SI B41 03 17
Body

SERVICE ACTION: WATER INGRESS BENEATH LUGGAGE COMPARTMENT

G30 (5 Series)			
----------------	--	--	--

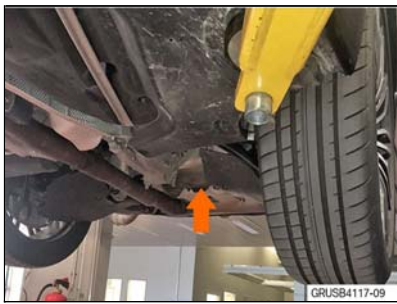
Possible water leakage into luggage compartment through PVC weld on floor. Accumulation of water in luggage compartment may not be noticed due to drain location in the vicinity.

Manufacturing process change moved PVC weld on underside of vehicle, beneath luggage compartment.

Repair PVC weld seam.

<p>GRUSB4117-09</p>	<ol style="list-style-type: none"> 1. Raise the vehicle on a lift.
	<ol style="list-style-type: none"> 2. Identify the critical area to be repaired as indicated.

3. Seal the existing seam.
4. Apply sealant generously over the critical area and be certain to spread it as shown.
